2014 - 2020 Corvette: Service Bulletin: #17-NA-271: Clicking Noise from Front Wheels While Turning at Slow Speeds

#17-NA-271: Clicking Noise from Front Wheels While Turning at Slow Speeds - (Oct 13, 2020)

Subject: Clicking Noise from
Front Wheels While
Turning at Slow Speeds

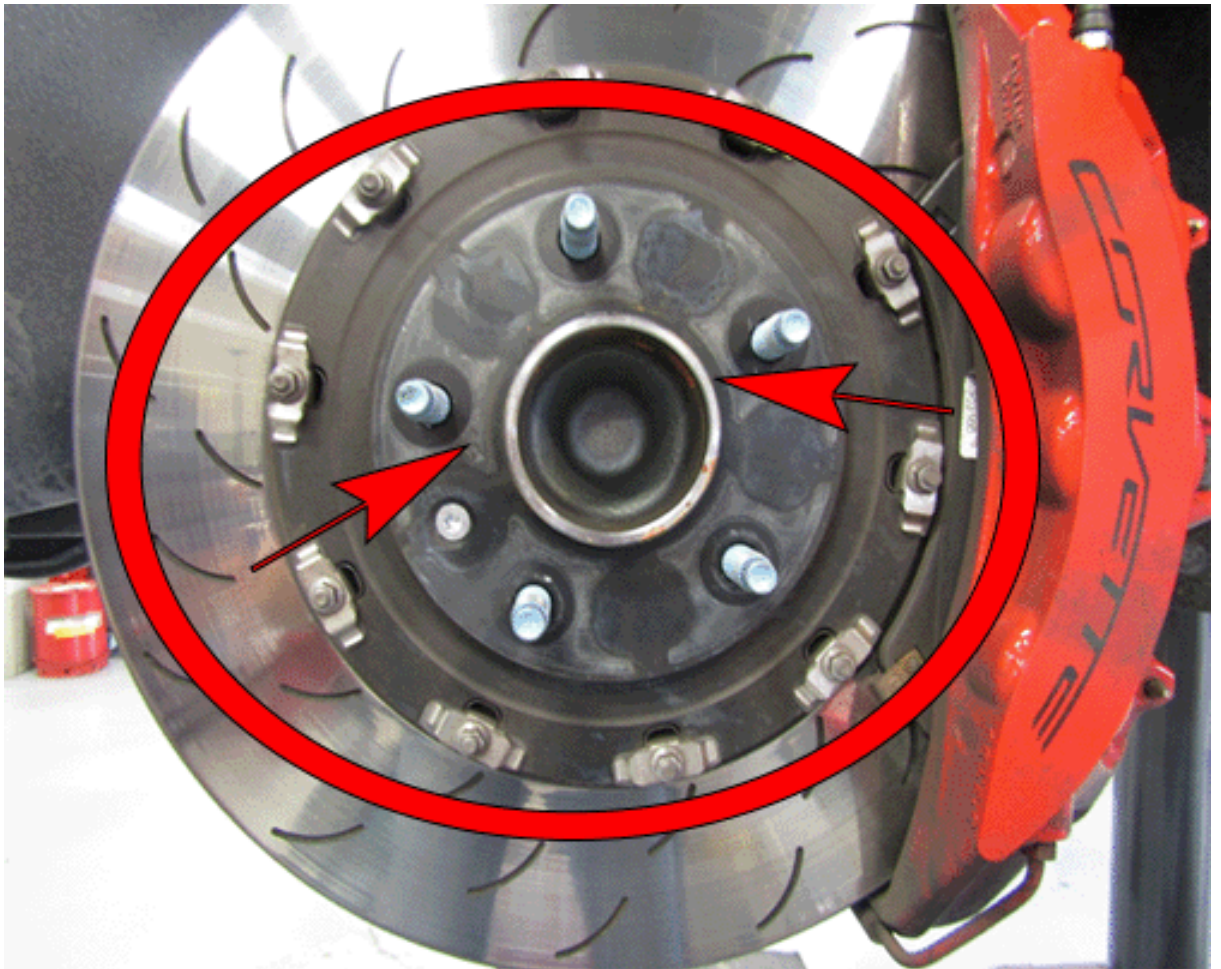
Some customers may comment on a

clicking noise emanating from the front wheels location. This condition may be more predominant at low speeds (16-32 km/h (10-20 mph) during full wheel lock turns on dry clean pavement.
<i>Cause</i>	This may be caused by interaction between the wheel mounting face and the wheel mounting surfaces on the brake rotor.
<i>Correction</i>	Clean both of the wheels mounting surfaces.
Service Procedure

Important: *DO NOT* replace the wheels or brake rotors for this condition.

1. Remove both of the front wheels. Refer to *Tire and Wheel Removal and Installation* in SI.
2. Clean both of the wheel mounting surfaces as follows.
 - Using a clean cloth dampened with approved brake cleaner (ex. Part number 19370705 (U.S.), 88901247 (Canada)), wipe the mounting surface of the wheel(s) removing any residual grey or black material that has accumulated on the wheel mounting surfaces.

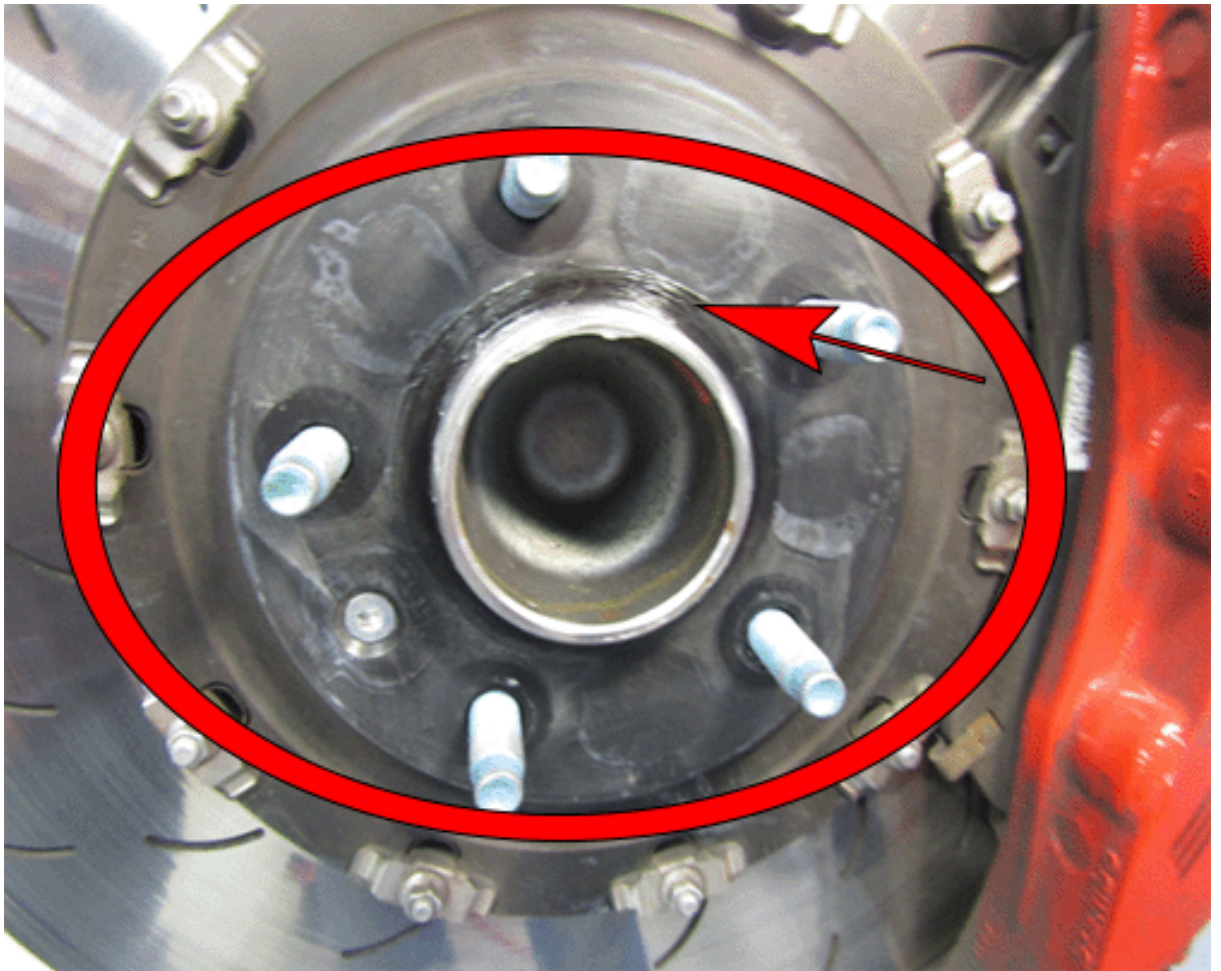
- Clean the wheel mounting surface of the brake rotors, or sometimes referred to as the brake rotor top hats, as follows:

- Using 3M red Scotch-Brite 7447 pad or equivalent with approved brake cleaner (ex. Part number 19370705 (U.S.), 88901247 (Canada)), wipe the wheel mounting surface of the rotor (brake rotor top hat) and the wheel pilot at the center of the rotor, removing any residual grey or black material that has accumulated on the rotors.

Note: All cleaning must be done by hand. *DO NOT* use pneumatic or power tools.
